February 25, 2019  
GO2-19-027

Subject: **COLUMBIA GENERATING STATION, DOCKET NO. 50-397  
LICENSE AMENDMENT REQUEST FOR LICENSING BASIS CHANGE TO  
CONTROL ROOM AIR CONDITIONING SYSTEM**

**Figure 3 – Proposed Configuration (Division 1)**  
**Emergency Standby Alignment: CCH Supplied to AHU, SW Supports CCH**

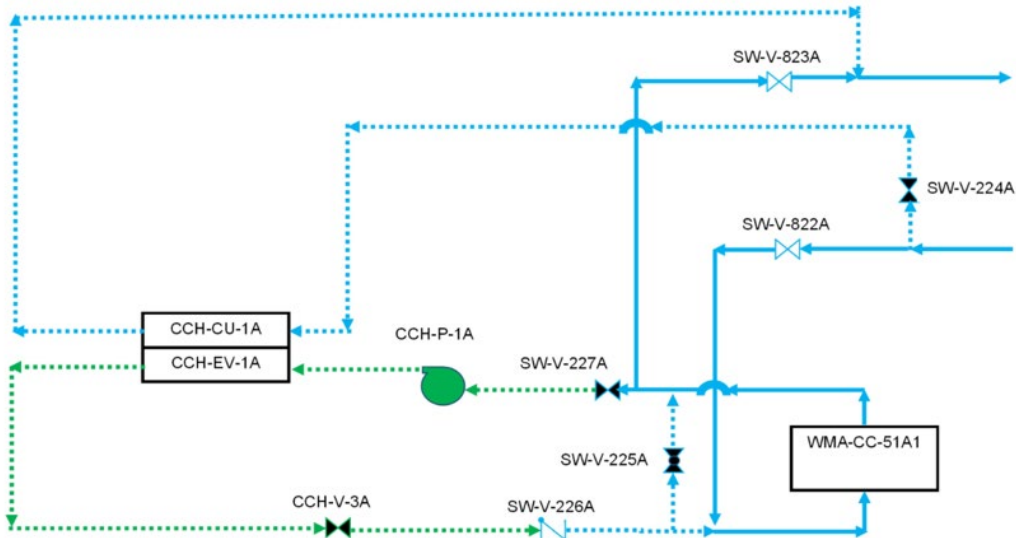
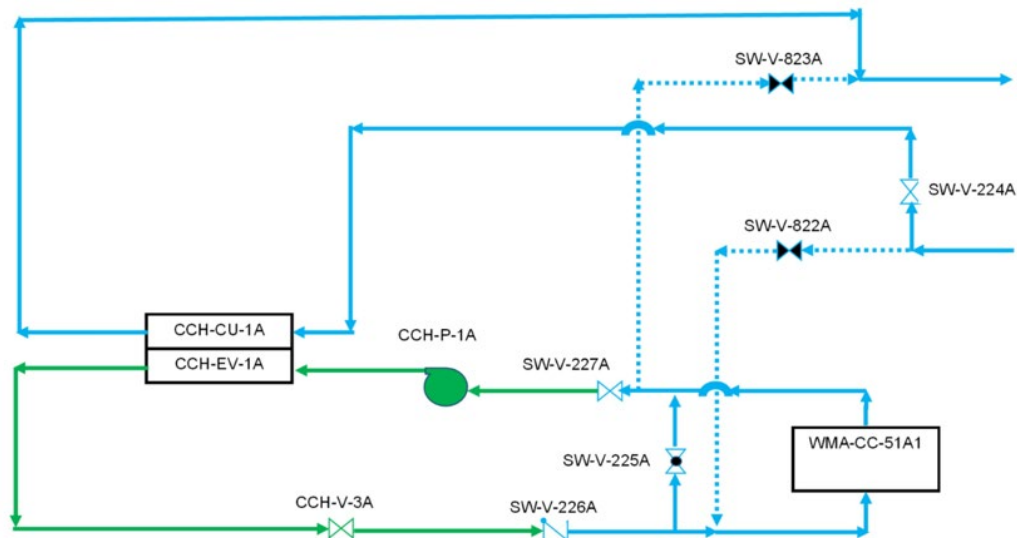
This License Amendment Request (LAR) proposes to utilize CCH as a cooling source to the Control Room AC system to meet the MCR 104°F equipment qualification temperature limit. SW is currently the identified cooling source to meet the 104°F limit.

- Upon approval of this LAR, the station will align CCH as the preferred cooling source to both Division 1 and Division 2 Control Room AC AHU emergency cooling coils. CCH and SW valves will be pre-set in the configuration that results in CCH supplied to the Control Room AC AHU emergency cooling coils and SW supplied as cooling to the CCH chiller condensers (see Figures 3 and 4).

- The current CCH design, which will be retained, requires manual start of the CCH system from the control room and local field operator action to load (adjust) the chiller for the required heat removal.

**Figure 4 – Division 2 (no change)**  
**Emergency Standby Alignment: CCH Supplied to AHU, SW Supports CCH**

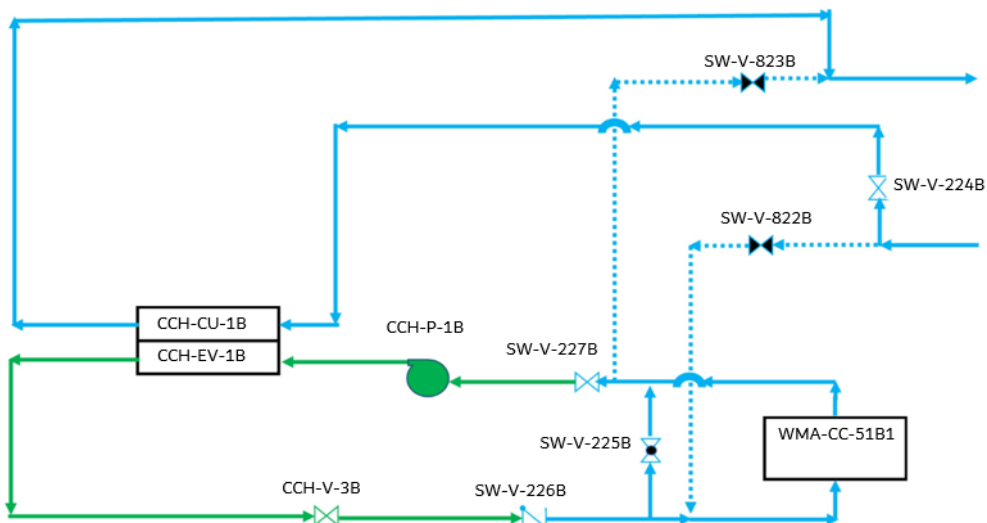
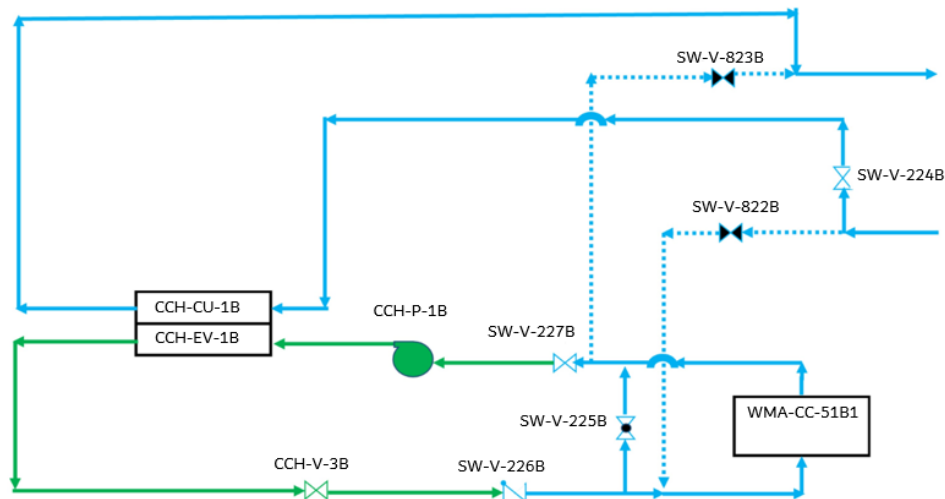
Figure 1 displays the current lineup of Division 1 with SW aligned to the AHU emergency cooling coil. Figure 2 displays the current lineup of Division 2 with CCH aligned to the AHU emergency cooling coil and SW aligned to the CCH chiller condenser.
